Sub: Corrigendum-01: Amendment to Tender specification document & due date extension

- 1. E-Tender specification No: 2101094
- 2. **Scope of work:** Detailed drawing preparation based on Input design drawings provided by BHEL-Engineering Centers for Flue Gas Desulphurization (FGD) Package as specified in scope and getting approval from BHEL- Engineering Centers/ NTPC. Fabrication and supply of finished product (procurement of raw structural steel will be in the scope of bidder) i.e. structures of FGD as per BOM/Drawings at 2X500 MW NTPC Mauda, Stage-I, TPP-FGD, Maharashtra.

2 X 500 MW MAUDA STPP-FGD PACKAGE			
DWG / DOC NO AND TITLE : 9561-109-ISG-PVC-B-445 - CONVEYOR LBC-1AB-GA OF GALLERY & TRESTLES R0				
SL NO	NTPC COMMENTS	BHEL REPLY		
1	Hold	Staad file has been revised and errors resolved		
2	PTFE bearing shall be provided for slinding support	Accepted. PTFE indicated in elevation view.		
3	COMPLY TO COMMENTS MARKED DESIGN DOCUMENT	Complied		
4	DESIGN/DRAWING TO CONFORM TO LATEST MECHANICAL/ELECTRICAL GADRG.	Accepted. Trestle Tr-2A introduced for structural requirement, after discussion with mechanical. The same will be updated in Mech GA dwg.		
5	ALL FURTHER CHANGES TO BE I

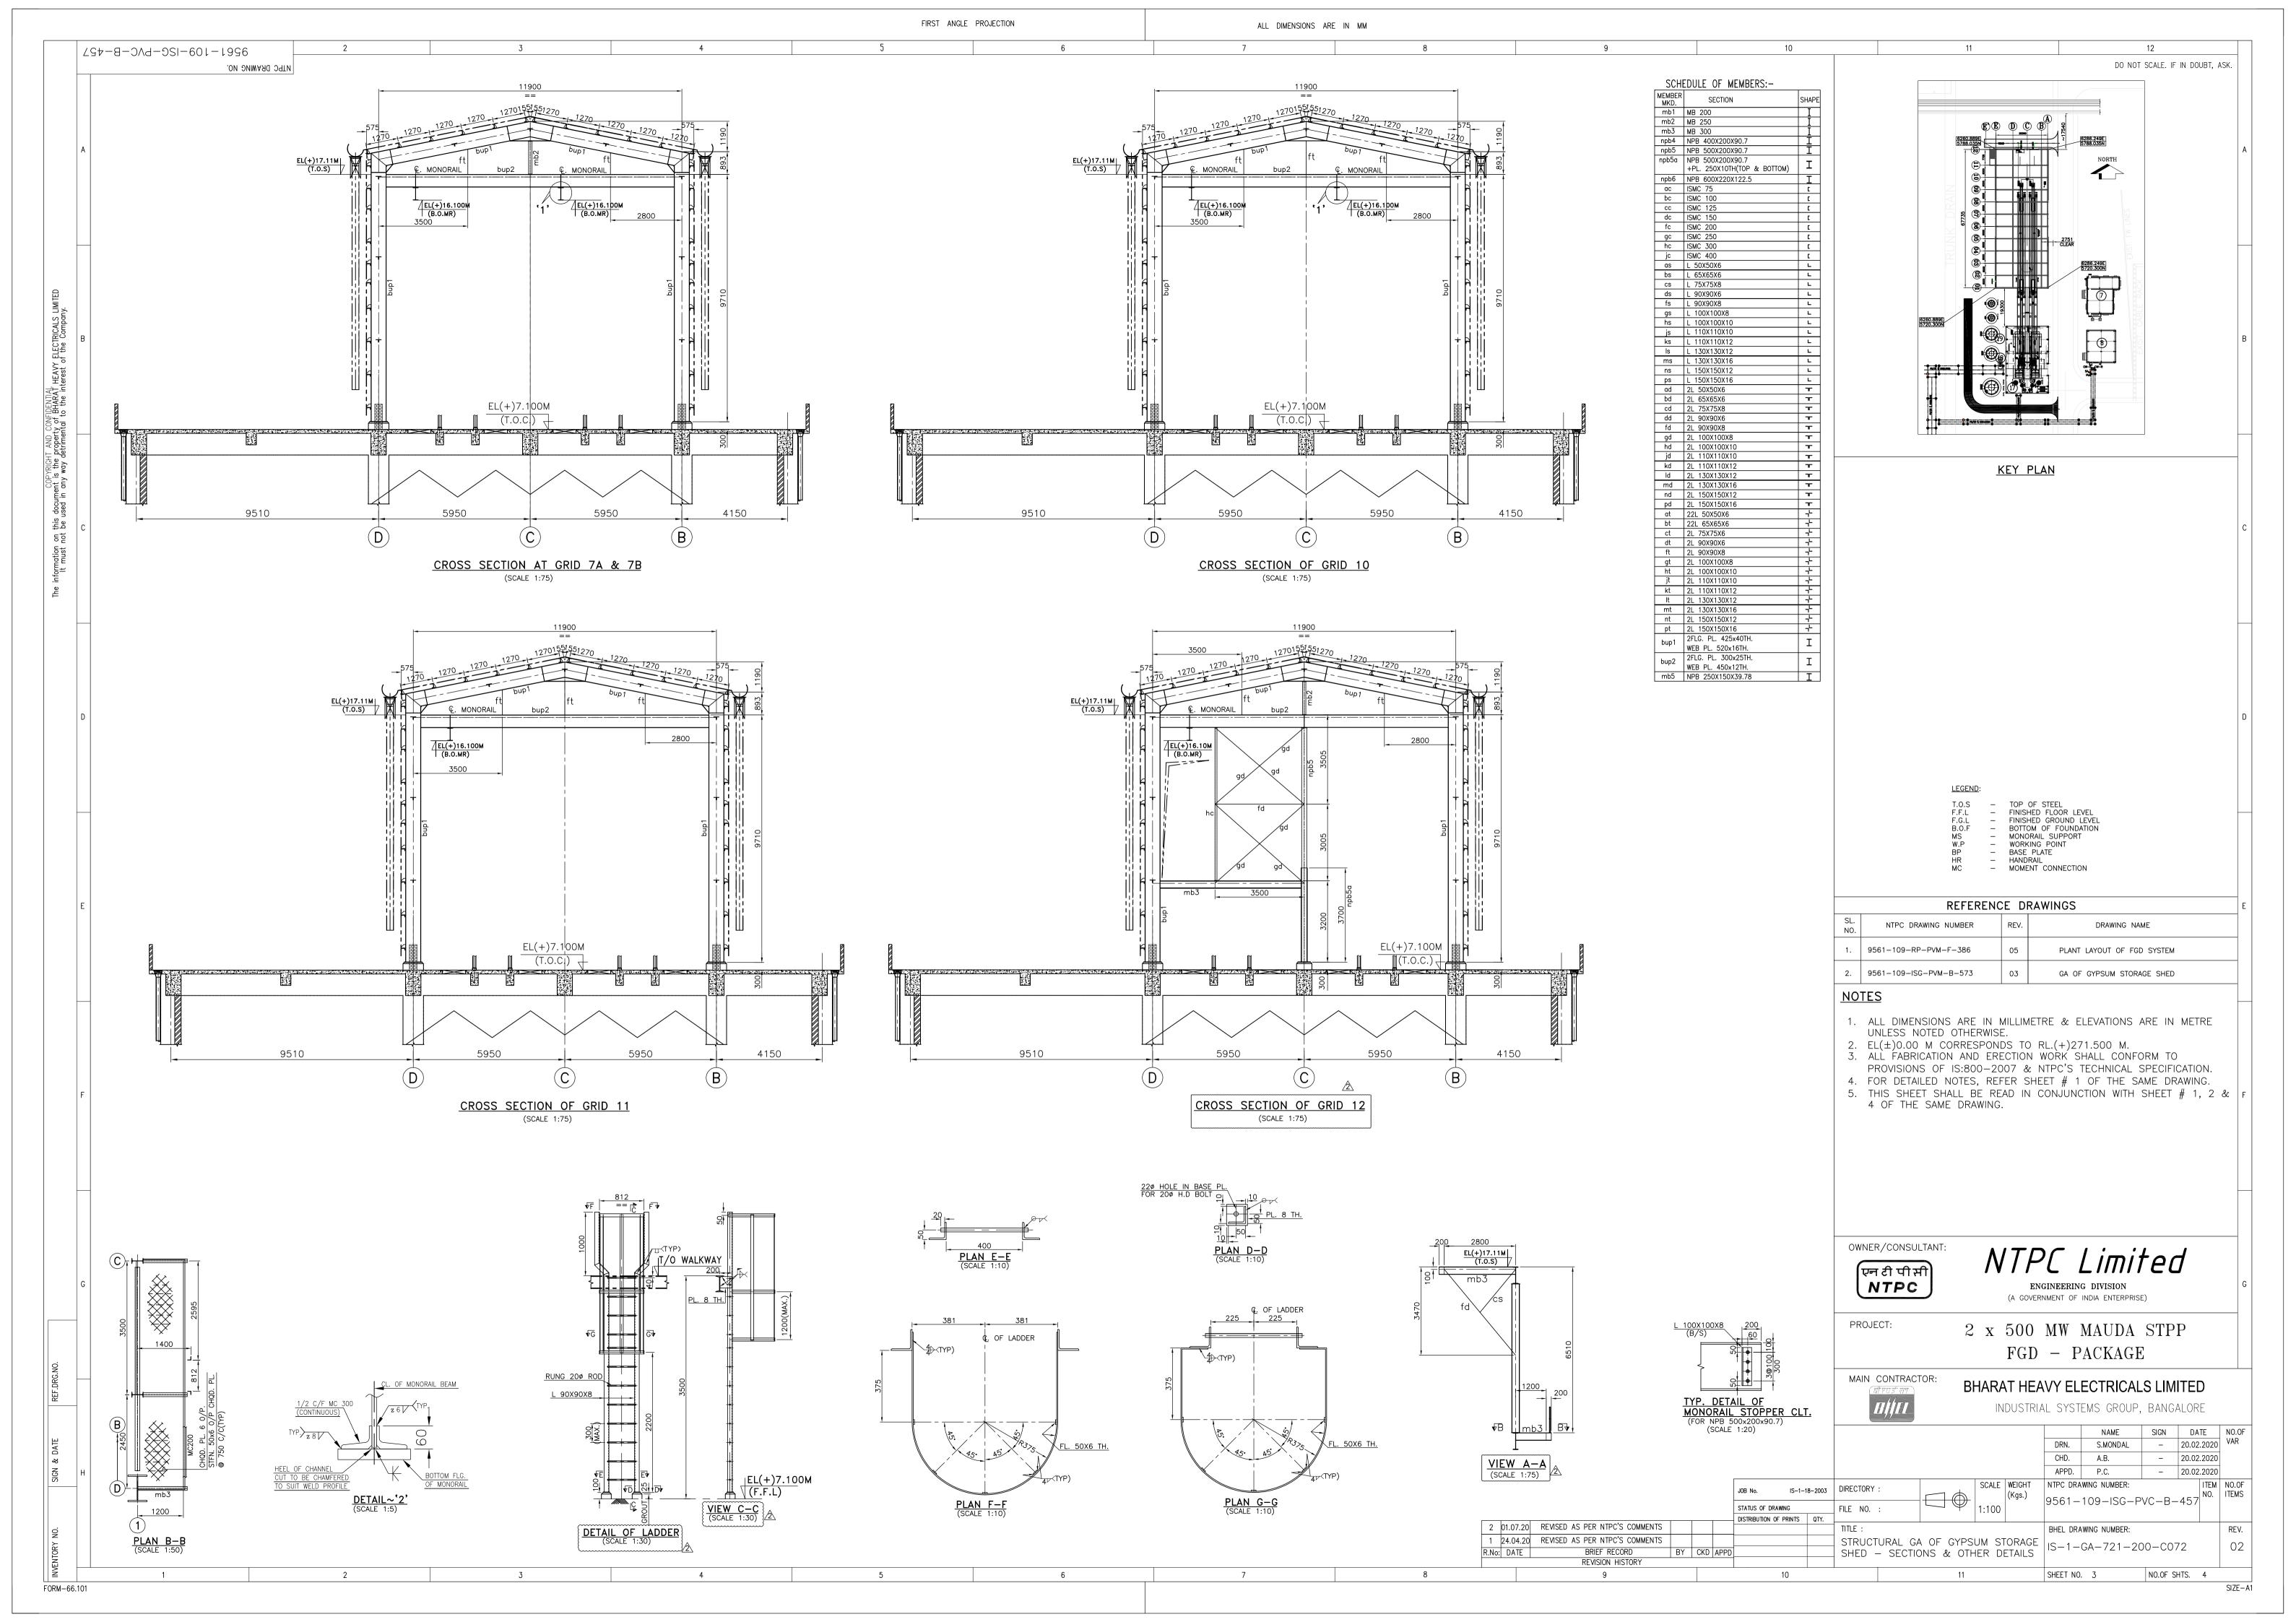
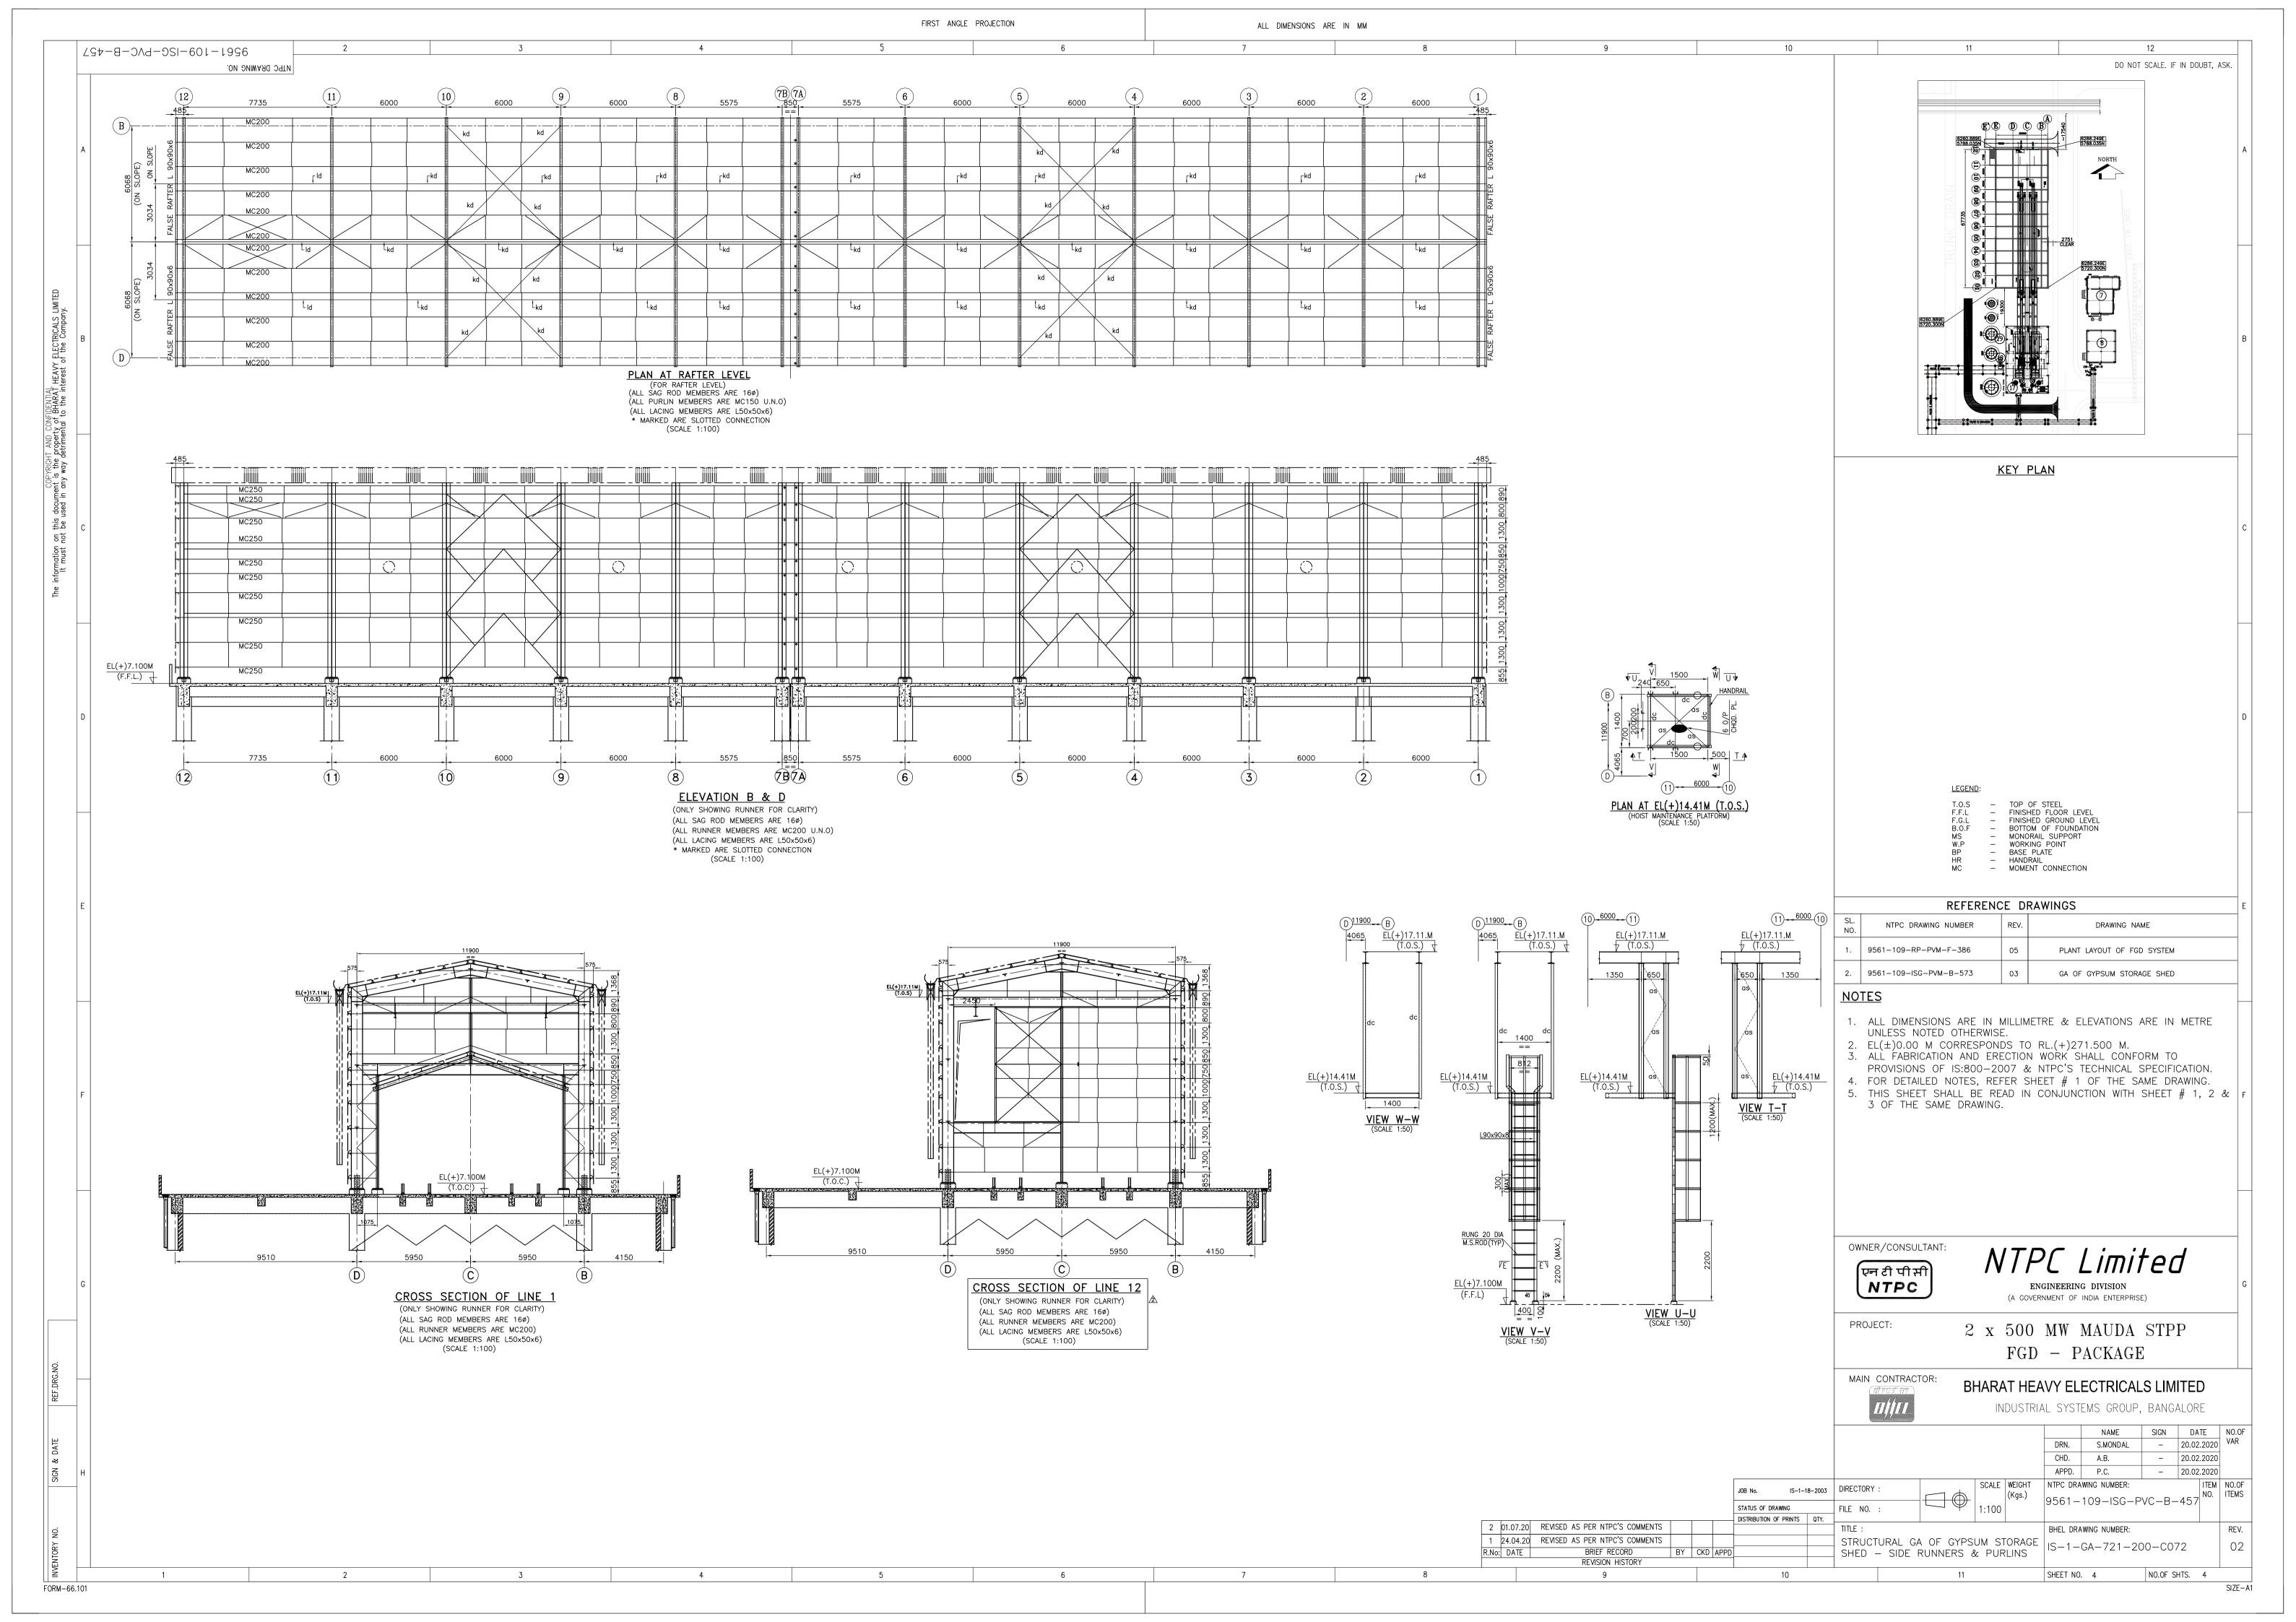
2 X 500 MW MAUDA STPP-FGD PACKAGE		
DWG / DOC NO AND TITLE : 9561-109-ISG-PVC-B-456 - STRUCTURAL DESIGN CALCULATION FOR GBC-1AB GALLERY & TRESTLES-R0			
SL NO	NTPC COMMENTS	BHEL REPLY	
1	DESIGN/DRAWING TO CONFORM TO LATEST MECHANICAL/ELECTRICAL GA DRG.	Accepted. Trestle Tr-1A has been introduced as per structural requirement. The same has been informed to mechanical after discussion.	
2	ALL FURTHER CHANGES TO BE INCORPORATED IF ANY.	Agreed.	
3	ALL PREVIOUS COMMENTS, IF ANY, ARE DEEMED TO HAVE BEEN INCORPORATED.	Noted.	
4	Vendor to recheck before taking up construction-Approval does not absolve the turnkey contractor from ensuring structural safety and functional adequacy of the structure.	Accepted.	
	utilization ratio is high and some of the members are failing please check and provide next higher section	Members revised in staad and drawings	
6	incorporate comment marked in structural document	Incorporated

7	incorporate comments marked in structural drawing	Incorporated
